**Application for Waiver from Construction Standards for Public Water Systems**

Water System Name: Portland Water Bureau

Project or Facility: SE 21<sup>st</sup> Ave & Nehalem

Construction standard requested to be waived: OAR 333-061-0050 (9)(b) water sewer separation

# SE 21st Ave

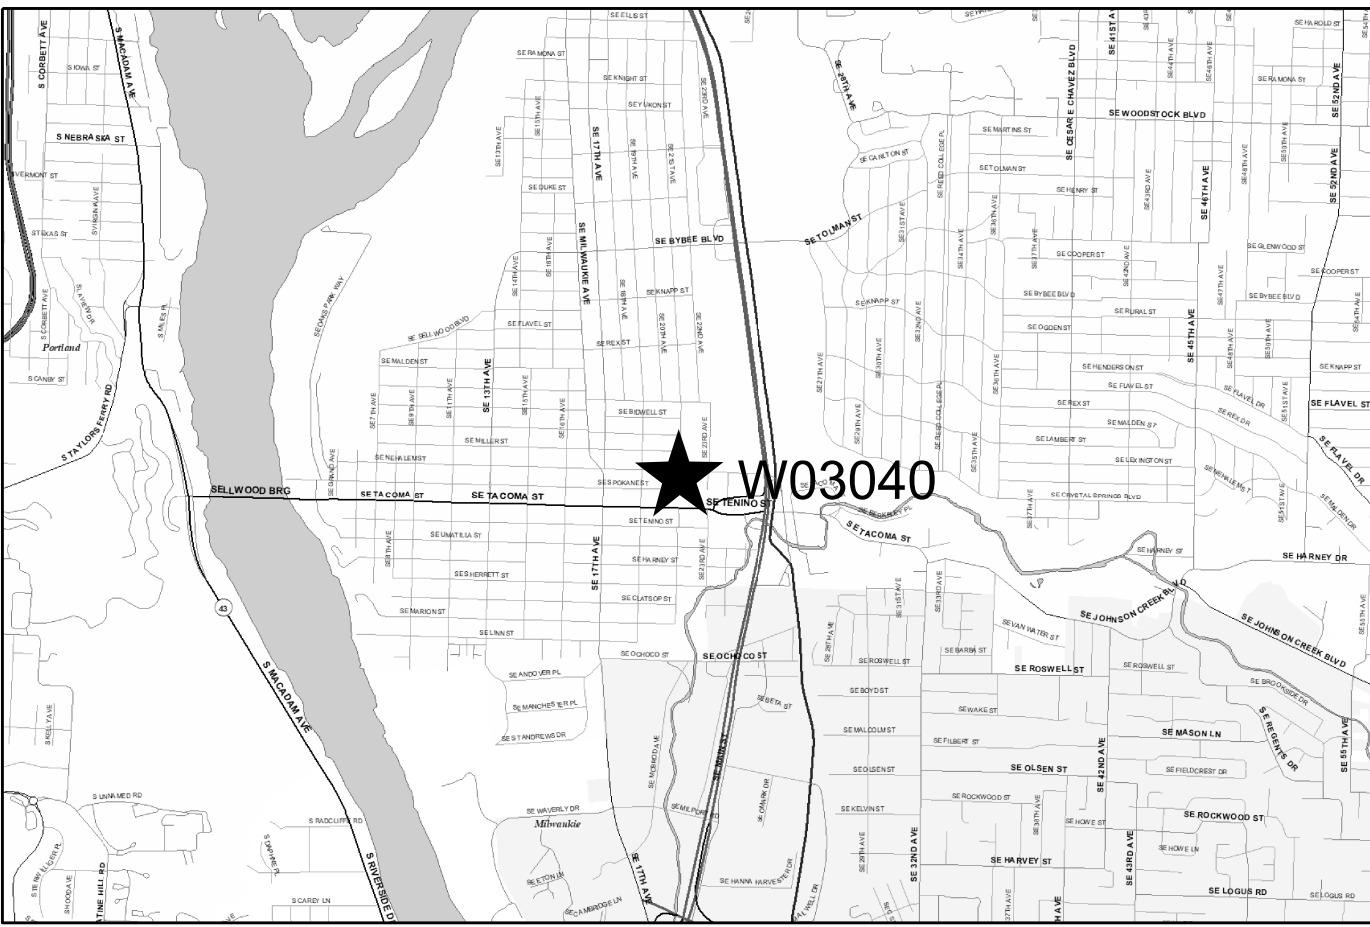
Describe situation that conflicts with the standard. A proposed water pipe will cross (<45 degrees) over top of an angled existing sanitary sewer pipe. The sewer is >9' deep, creating a Zone 2 parallel conflict from 2+08 to 2+50.

Describe why meeting the standard is highly burdensome or impractical. Since the angled sewer crosses the entire right of way, the proposed water must cross it somewhere.

Describe proposed alternate measure that provide adequate protection to public health and safety. The proposed water pipe will be encased in CLSM for the segment where it is within 5' of the existing sewer.

☒ Plan Review Coordinator's notes: Proposed encasement with CLSM is an appropriate remedy for the Zone 2 conflict.
